Attachment A
Section 92 Response,
parts 1, 2, 3

25 January 2024

Attachment A: Section 92 response

Table 1: Proposed Flood Hazard Condition – changes since lodgement and rationale

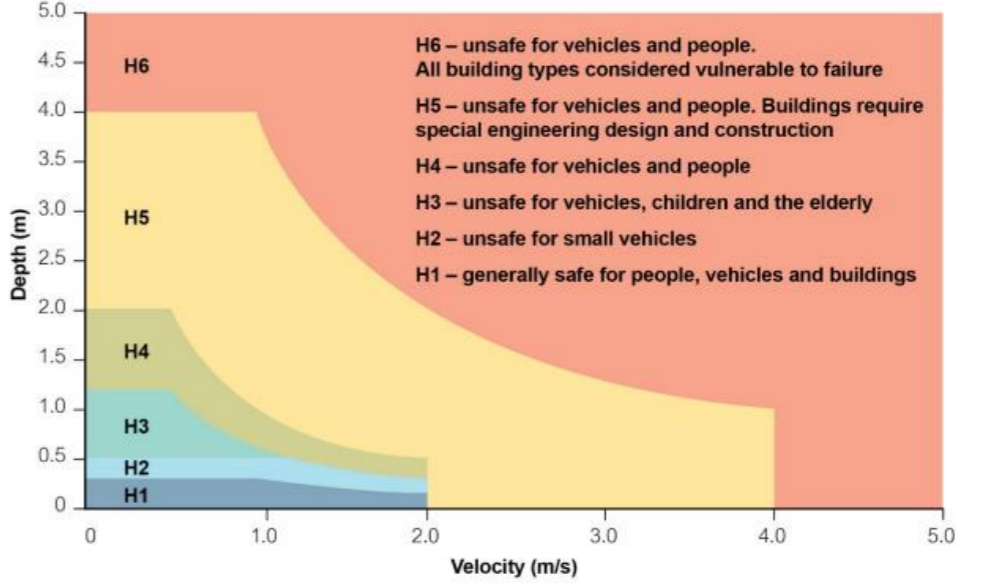
The table below sets out the Flood Hazard condition proposed at lodgment, the changes proposed as a result of a review of the condition carried out in December 2023 and our reasons for those changes.

Condition as lodged Sept 2023 (Appendix B, condition 10)	Proposed change to condition	Rationale for change from conditions as lodged
(a) The Project shall be designed to achieve the following flood risk outcomes:	The Project shall be designed to achieve the following flood risk outcomes:	N/A
<ul style="list-style-type: none"> i. no increase in flood levels in a 1% AEP event for existing authorised habitable floors that are already subject to flooding or have a freeboard less than 150mm; 	<ul style="list-style-type: none"> no increase in flood levels in a 1% AEP event for existing authorised habitable floors that are already subject to flooding or have a freeboard less than 150mm500mm; 	<p>A site assessment was carried out to estimate the amount of freeboard at buildings that might be affected by flooding close to the proposed NoR boundary (refer Section 4 and the maps in Appendix 1 of the Supplementary Flood Hazard Assessment). When the freeboard was estimated, the majority of those existing floors assessed were either flooded or within 150mm of flooding. Changing to 500mm had a minor increase in the number of floors subject to this condition but the controlling criteria was typically the building with freeboard less than 150mm.</p> <p>The new criteria also provides better protection for relatively new buildings that may be constructed prior to lodgement of the OPW– which is relevant to NoRs near flooding within the Future Urban Zone.</p> <p>Increasing freeboard to 500mm for these types of buildings aligns with freeboard standards in the AC Stormwater Code of Practice for new builds.</p> <p>It is not intended to protect all future buildings – those constructed after the OPW are lodged are expected to set appropriate freeboard above the Post project flood level.</p>

<ul style="list-style-type: none"> ii. no more than a 10% reduction in freeboard in a 1% AEP event for existing authorised habitable floors with a freeboard over 150mm; 	<ul style="list-style-type: none"> no more than a 10% reduction in freeboard in a 1% AEP event for existing authorised habitable floors to maintain a minimum with a freeboard of over 150mm; 	<p>A percentage freeboard reduction is not needed if a freeboard of 500mm is utilised in criteria i.</p>

Condition as lodged Sept 2023 (Appendix B, condition 10)	Proposed change to condition	Rationale for change from conditions as lodged
<p>iii. no increase in 1% AEP flood levels for existing authorised community, commercial and industrial building floors that are already subject to flooding;</p>	<p>no increase in 1% AEP flood levels for existing authorised community, commercial, industrial and network utility building floors that are already subject to flooding or have a freeboard of less than 300mm;</p>	<p>This criterion has been introduced to address flood effects as these types of building are present in the Project area – such as east of SH1 (NoR4).</p> <p>Increasing the freeboard to 300mm for these types of buildings aligns with freeboard standards in the AC Stormwater Code of Practice for new builds.</p> <p>Given the potential town centre areas in the Future Urban Zone there is potential for more of them to be constructed prior to the lodgement of the OPW. The new criteria provides better protection for relatively new buildings.</p>

<p>vi. no new flood prone areas;</p>	<p>no new flood prone areas; and</p>	<p>No change.</p>
<p>vii. no more than a 10% average increase of flood hazard (defined as flow depth times velocity) for main access to authorised habitable dwellings existing at time the Outline Plan is submitted. The assessment shall be undertaken for the 1% AEP rainfall event.</p>	<p>No increase of flood hazard for main vehicle access to authorised habitable dwellings existing at time the Outline Plan is submitted. The assessment shall be undertaken for the 1% AEP rainfall event. Where Flood Hazard is:</p> <ul style="list-style-type: none"> • Velocity x depth >= 0.6 or • depth > 0.5m, or • velocity >2m/s. <p>no more than a 10% average increase of flood hazard (defined as flow depth times velocity) for main access to authorised habitable dwellings existing at time the Outline Plan is submitted. The assessment shall be undertaken for the 1% AEP rainfall event.</p>	<p>The wording has been changed to reflect the change from category H2 to H3 in the Australian Institute of Disaster Resilience 2017, Handbook 7, Managing the Floodplain. Using categories of protection, allows some changes to depth or velocity within category 2 while providing appropriate protection.</p> <p>The protection of both pedestrians and small vehicles are covered within category H2.</p>
